SUBJECT: FORWARDS REQUEST FOR AMEND TO APP A OF LICENSE DPR-31 & DPR-41. AMEND COVERS CHANGING TECH SPEC LIMITS RE ECCS COOLING PERFORMANCE IN LIGHT OF WESTINGHOUSE REEVALUATION.

Re: Turkey Point Units 3 and 4
Docket Nos. 50-250 and 50-251
Proposed Amendment to Facility
Operating Licenses DPR-31 and DPR-41

Re: Turkey Point Units 3 & 4
Docket Nos. 50-250 & 50-251
Revised ECCS Analysis

Figures 3.2-2, 3.2-2a, and 3.2-2b

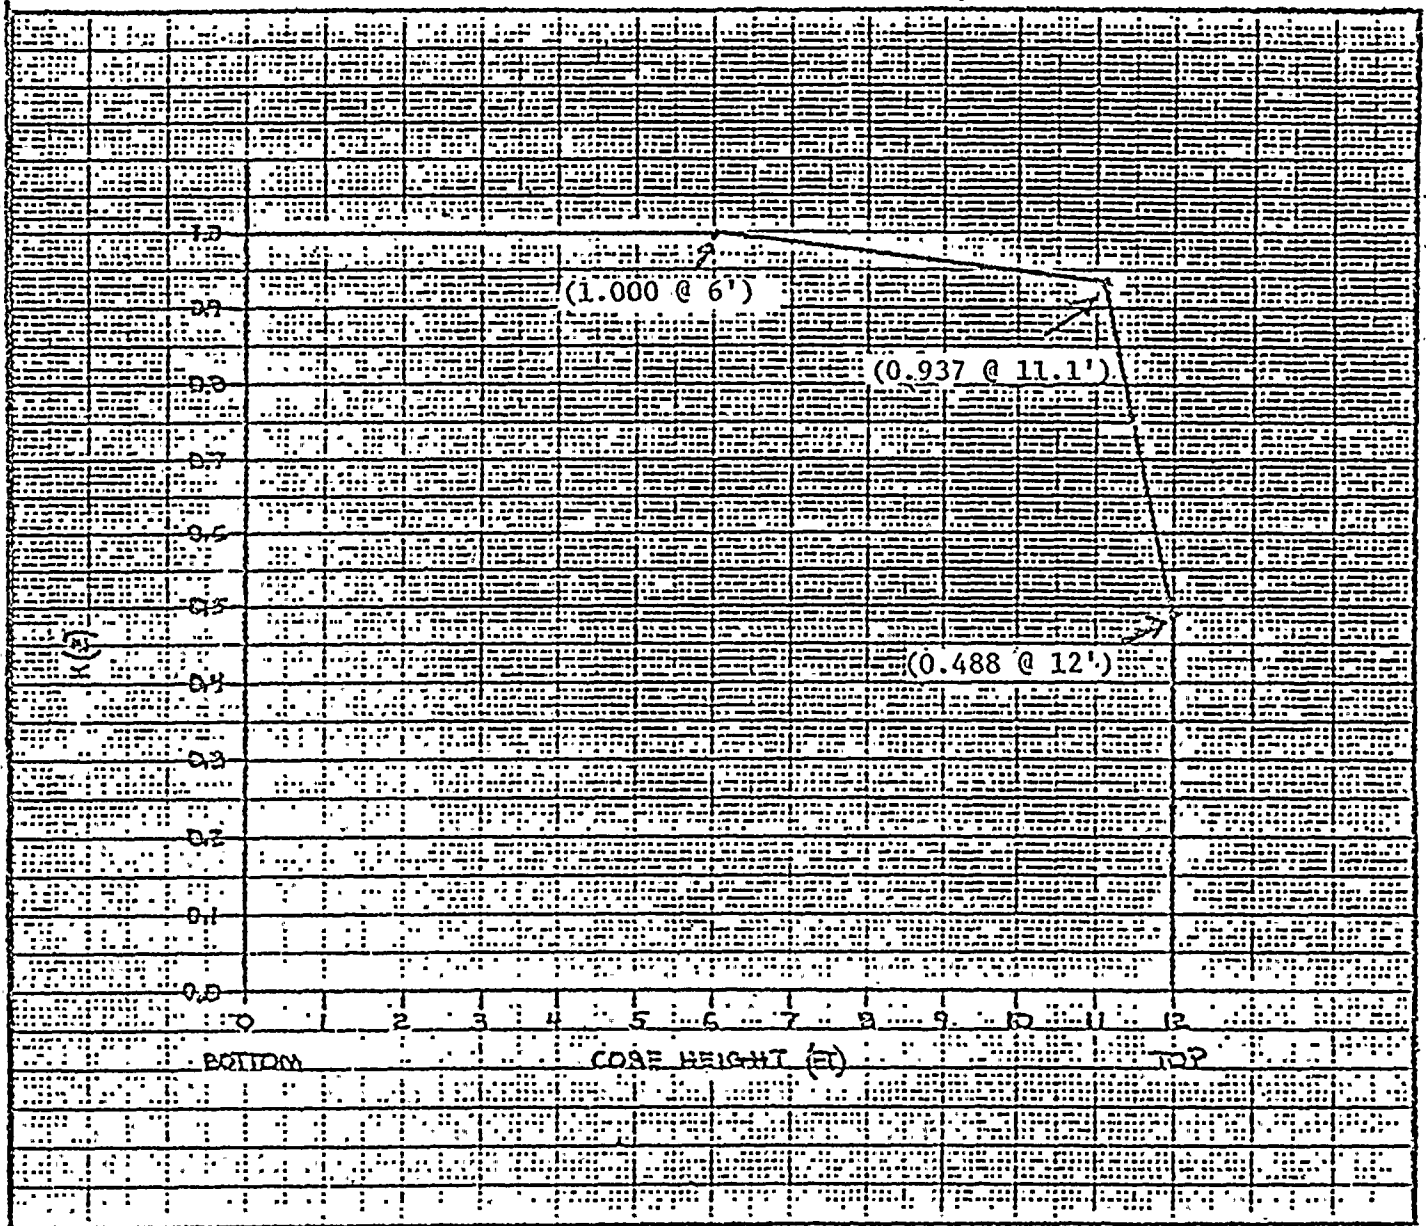
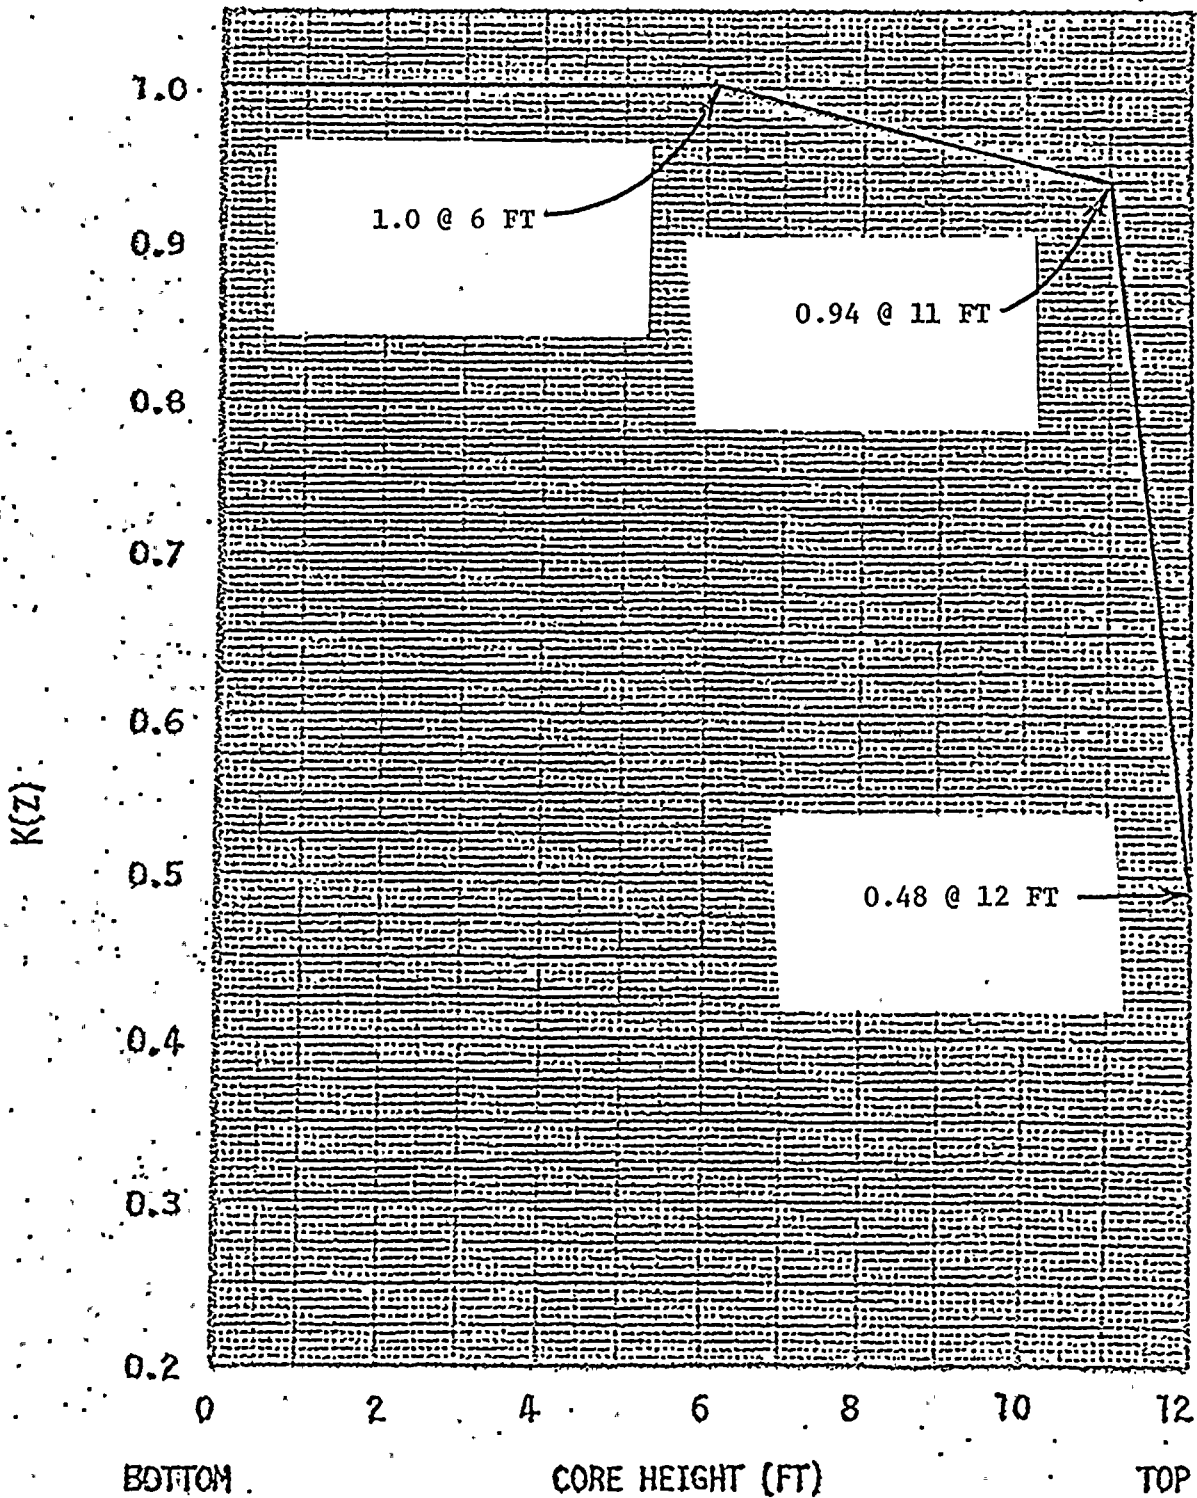
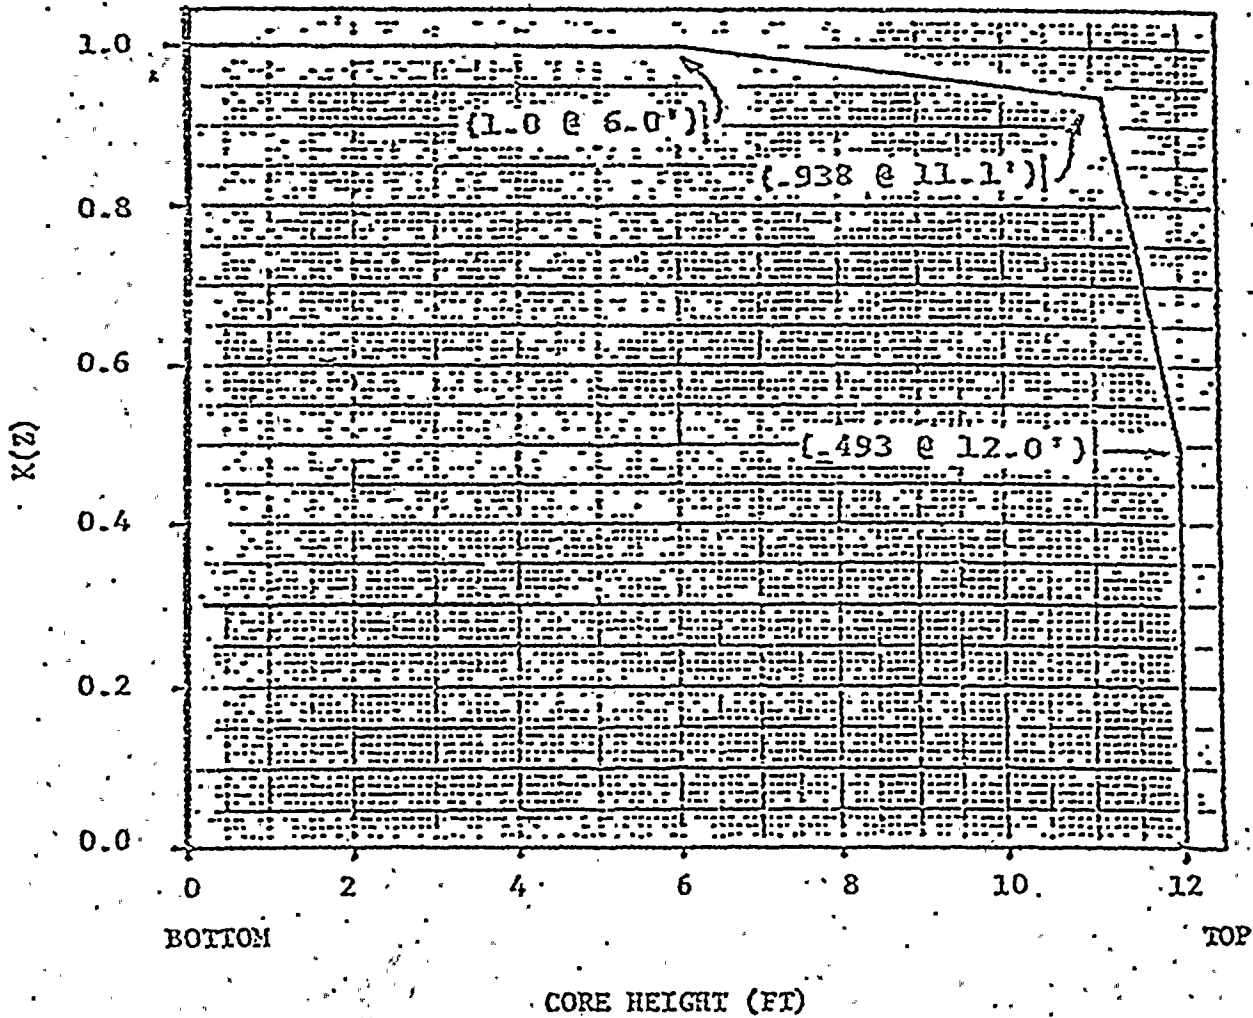
The two existing figures are renumbered and a third figure is added to provide successive Hot Channel Factor operating envelopes for 19%, 22%, and 25% steam generator tube plugging.

Bases Section B3.2 (Control and Power Distribution Limits) is revised to include reference to Figure 3.2-2a and 3.2-2b.
